Port Gamble S’Klallam Tribe
Public Works Department
31912 Little Boston Road, WA 98370

ADDENDUM 1

Pre-Bid Meeting Minutes and Questions from Site Walk and Emails

**MICROGRID DESIGN, PROCURE, AND INSTALLATION FOR ONE (1)
FACILITY**

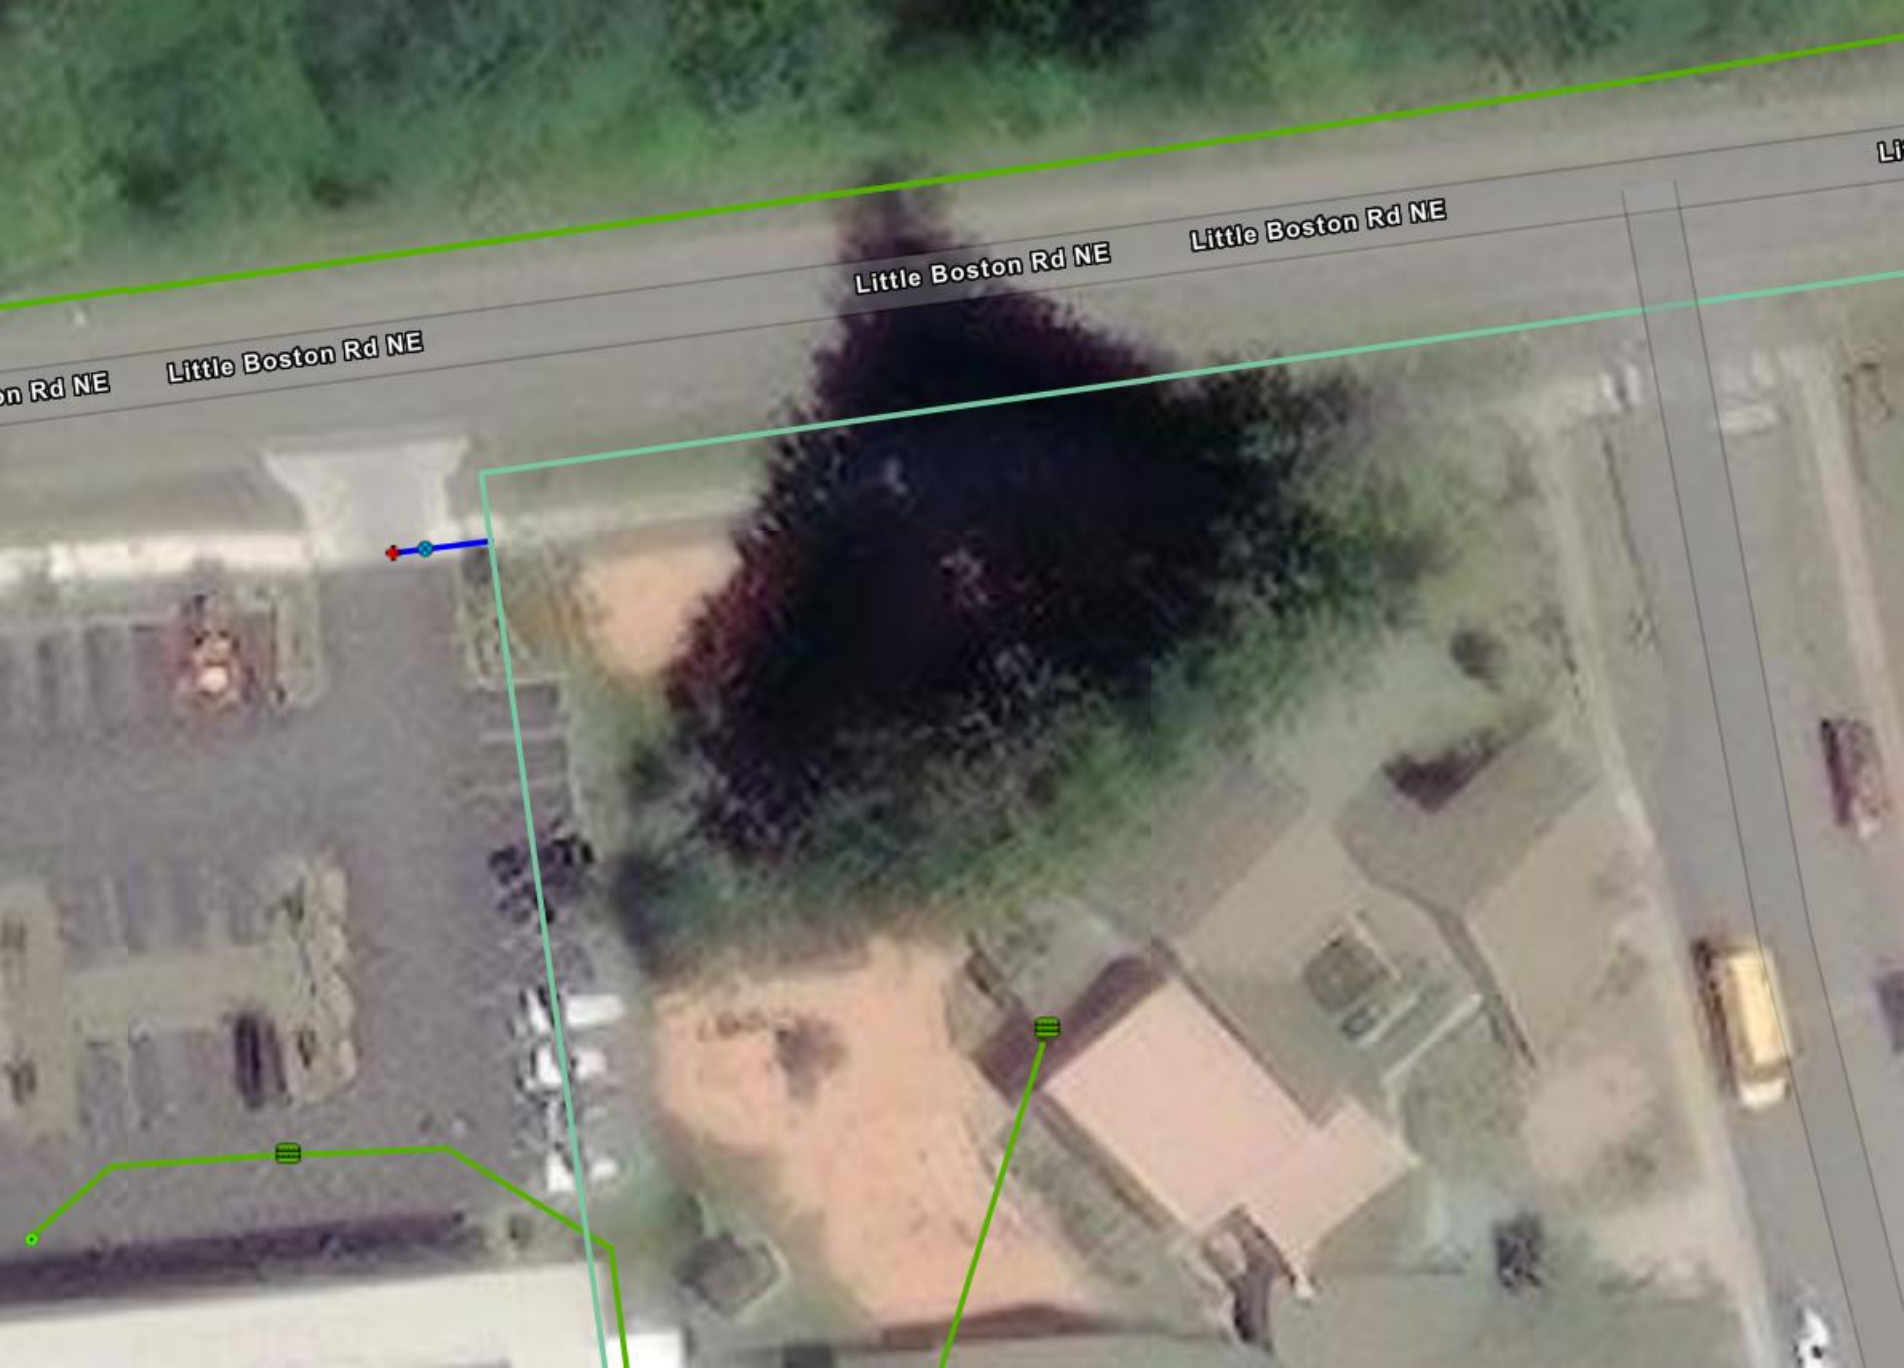
- No.
- 14. Can drawings be provided showing buried utilities in the vicinity?**
- Yes. Appendix D (part 1), Sheet C5 shows buried utilities; Water, Fire, sewer, and storm drain lines in close proximity to the building.

- A GIS map of the area showing approximate locations around the Clinic with Legend is also attached to this Addendum.
 - **Note: Impacts to these buried utilities was the top concern expressed by the Tribe** during planning and bid walk. Extreme care is required during trenching. This includes the recommended use of waterjet and hand excavation to reduce risk.
